ADDENDUM #1 Issued: January 6th, 2023

THE PURPOSE OF ADDENDUM IS TO <u>MAKE CHANGES</u>, AND P<u>ROVIDE ANSWERS TO THE REQUEST FOR</u> <u>CLARIFICATIONS</u> TO THE RFP DOCUMENTS.

Client/Project MONTGOMERY COLLEGE GERMANTOWN CAMPUS OBSERVATION DRIVE SIGN

Existing Conditions Plan

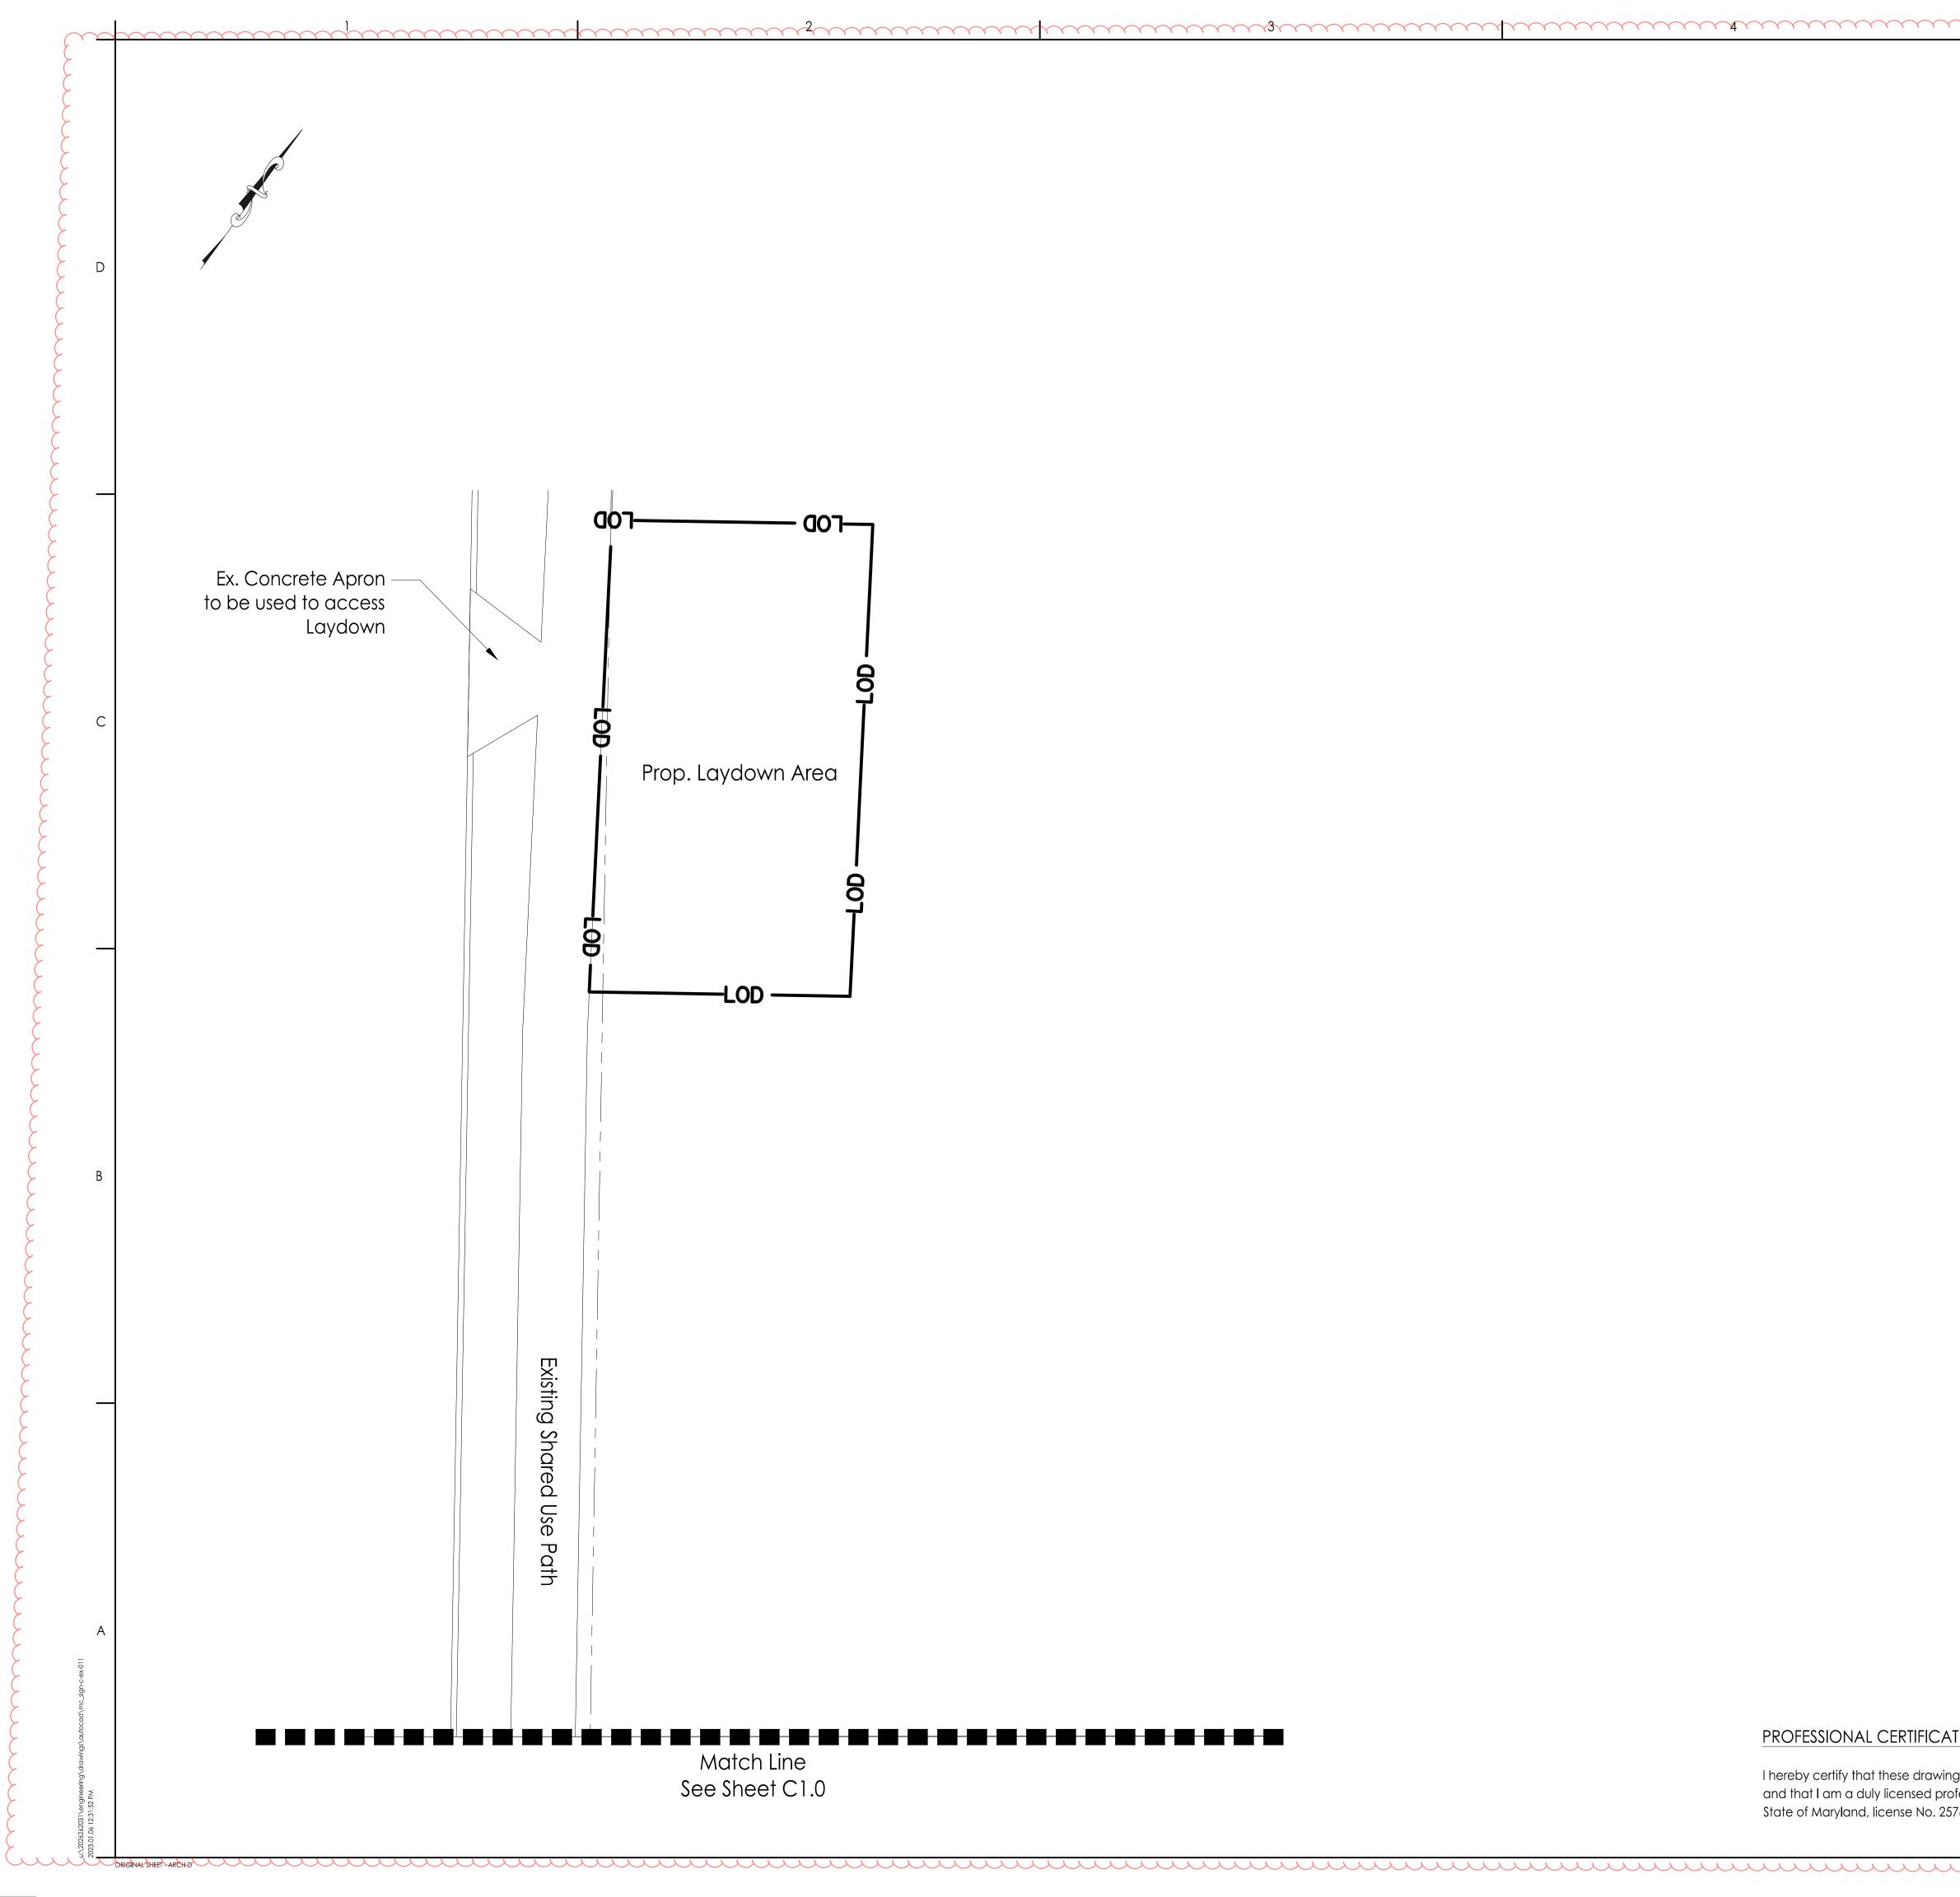
C1.0 – Drawing limits and Limit of Disturbance (LOD) revised to show extended project limits north along Observation Drive; notes added regarding the removal of existing No Parking Sign and existing obsolete telephone pole tie-down anchor within the project limits; Sheet Index updated.

WORK IN THE PUBLIC RIGHT OF WAY PLAN

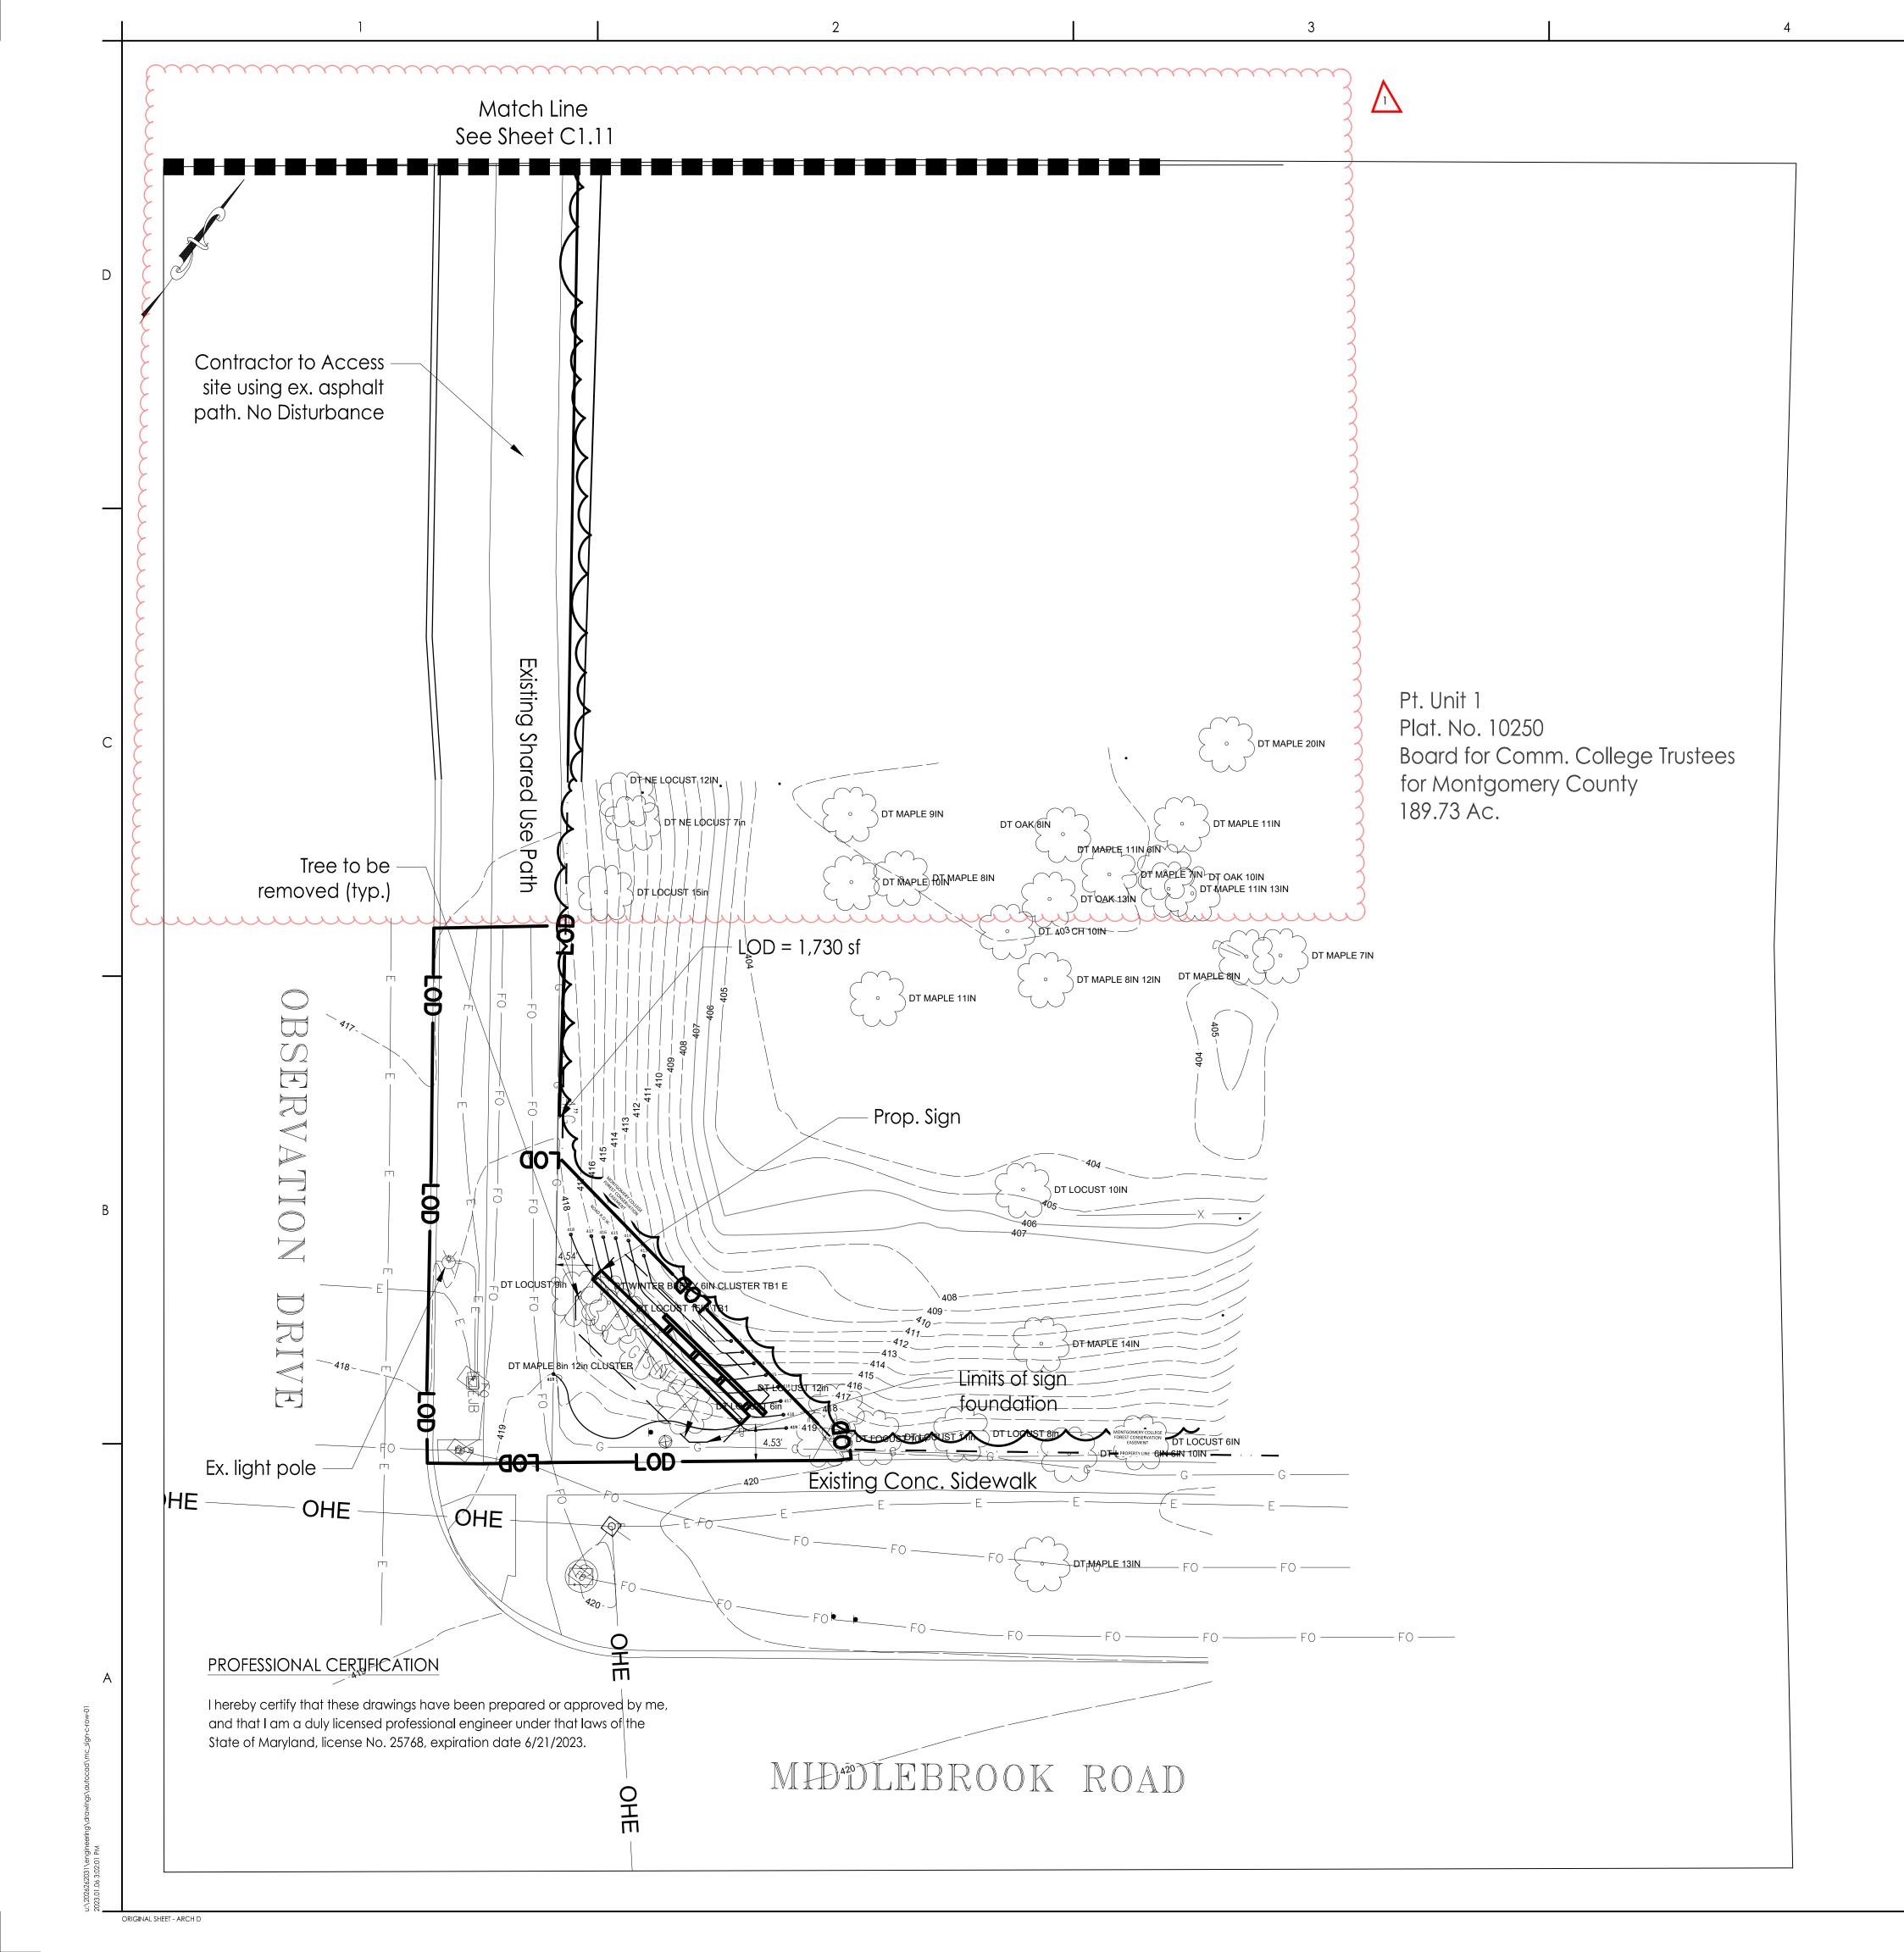
C1.1 – Drawing limits and Limit-of-Disturbance (LOD) revised to show extended project limits north along Observation Drive; Stabilized Construction Entrance (S.C.E.) re-located to correspond with existing curb cut and concrete apron.

WORK IN THE PUBLIC RIGHT OF WAY PLAN

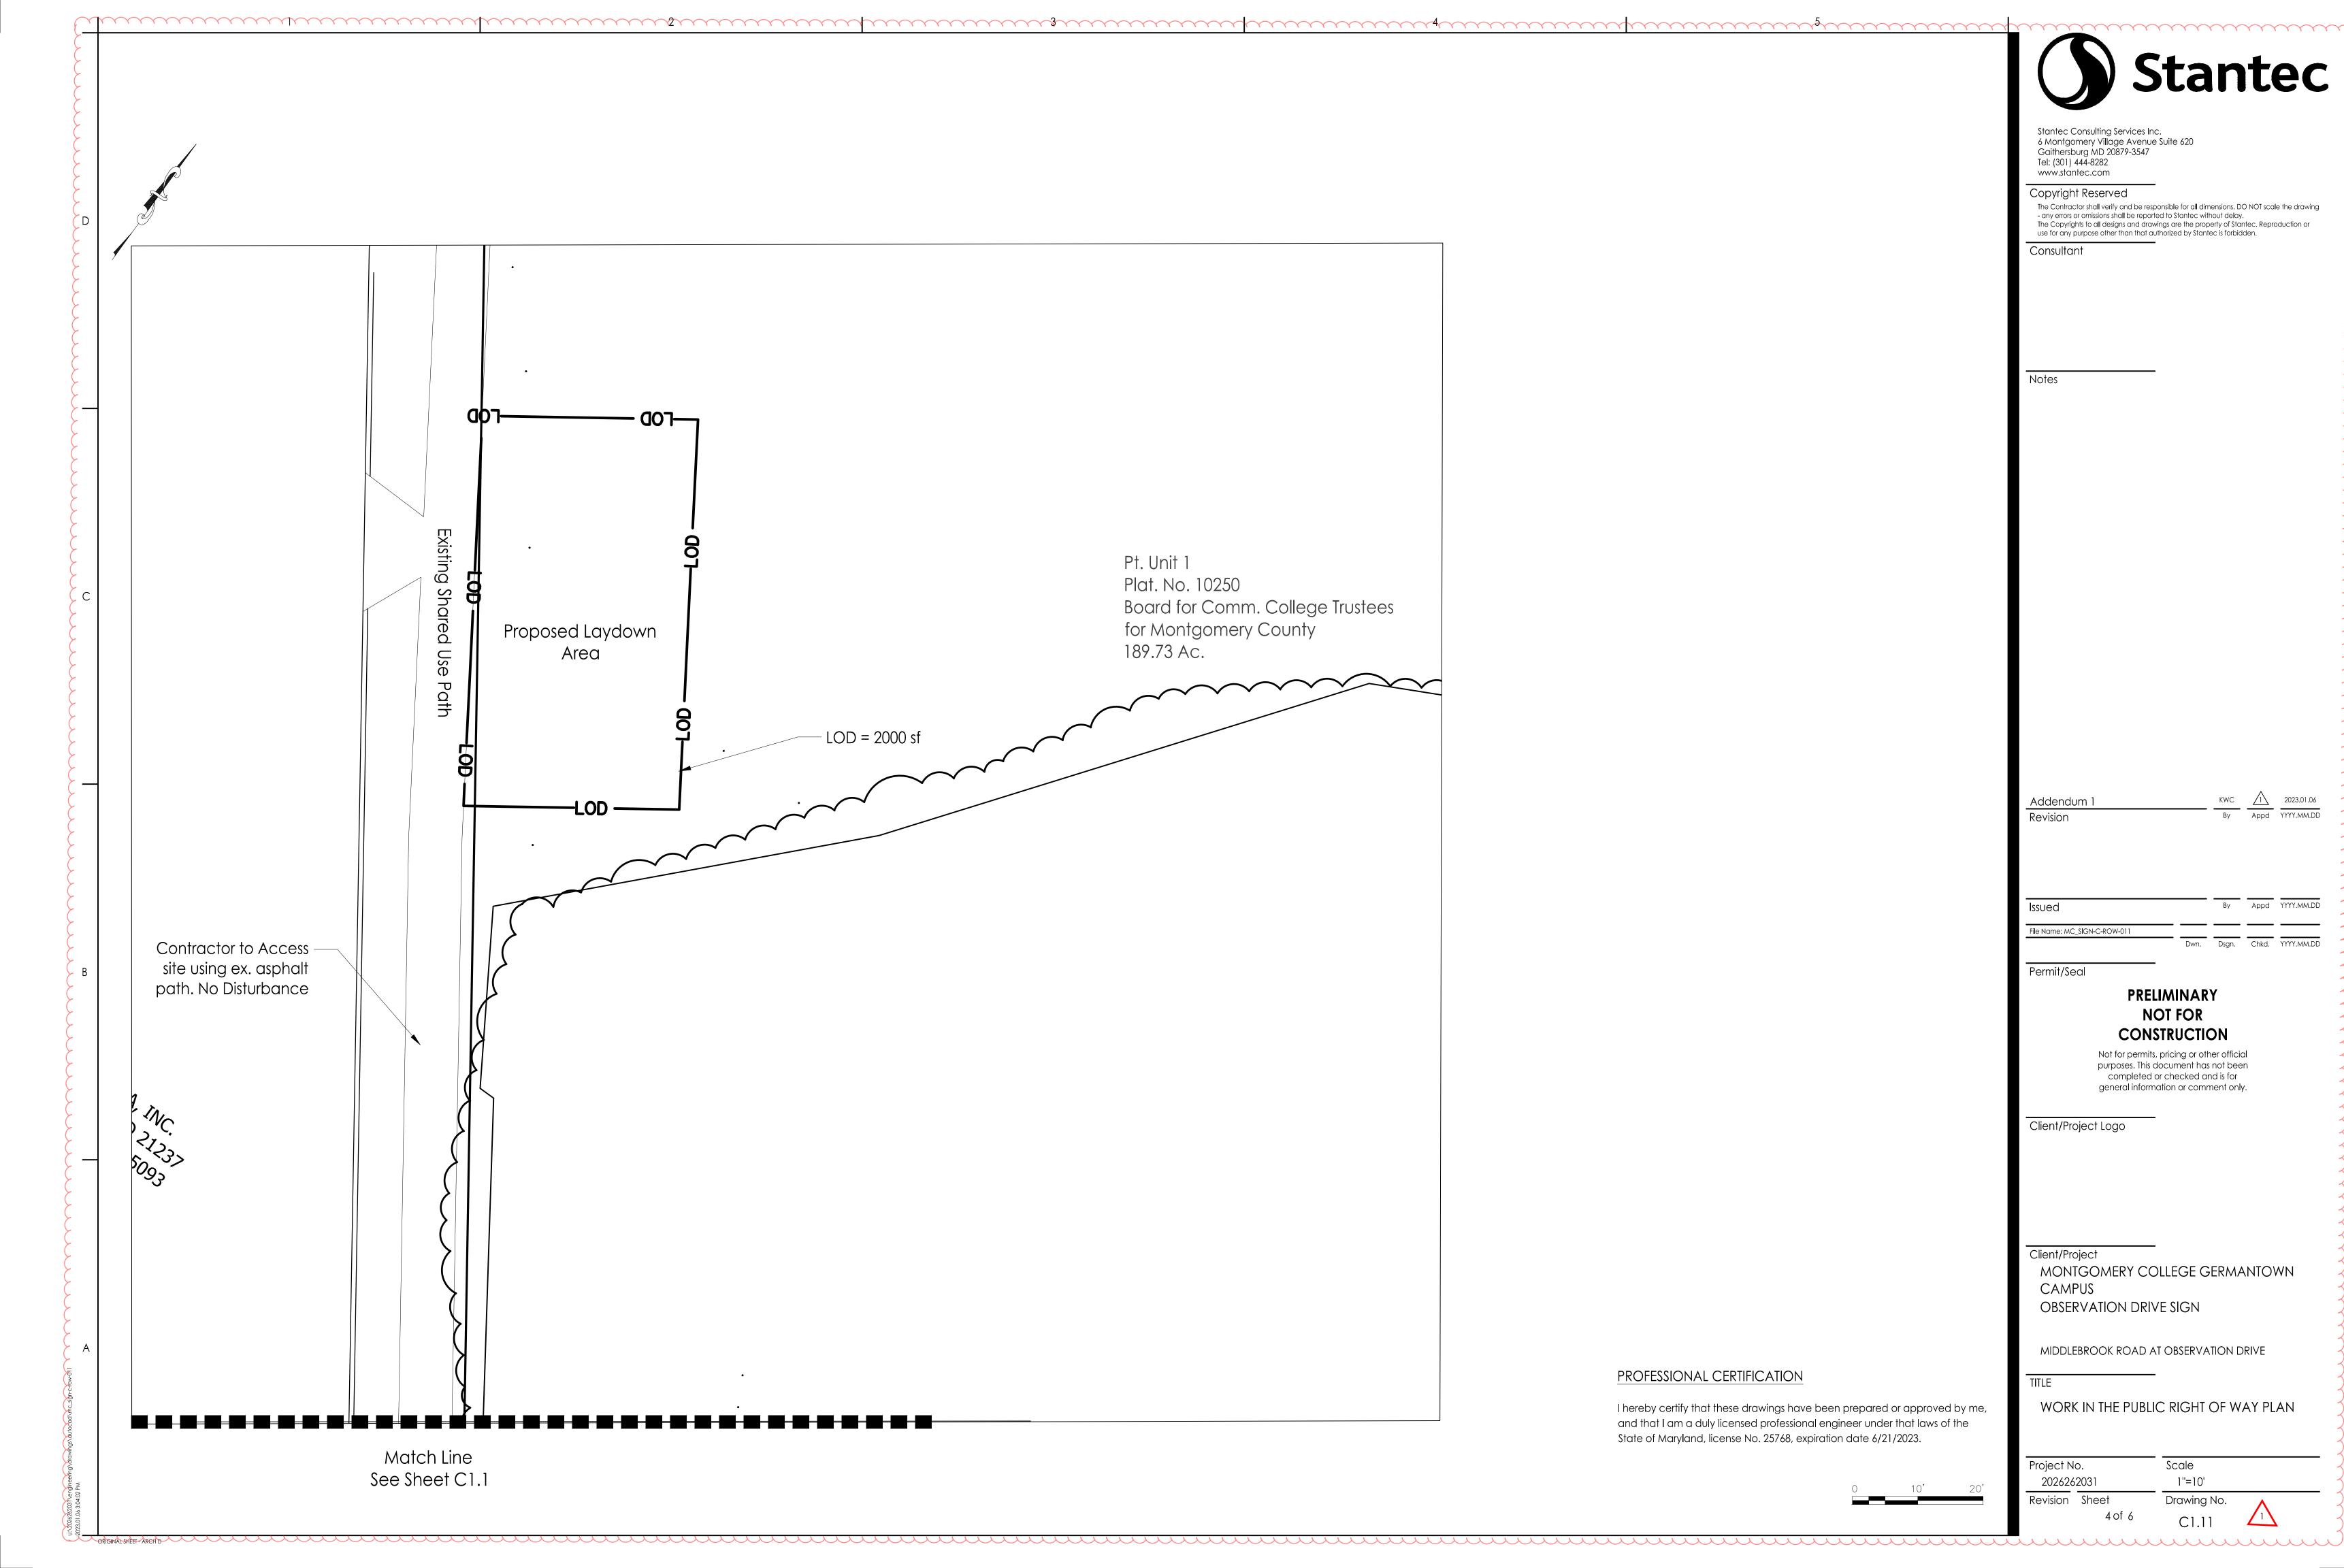
C1.11 – <u>*NEW SHEET*</u> Additional Work in the Public Right of Way Plan added to show extended project limits north along Observation Drive.
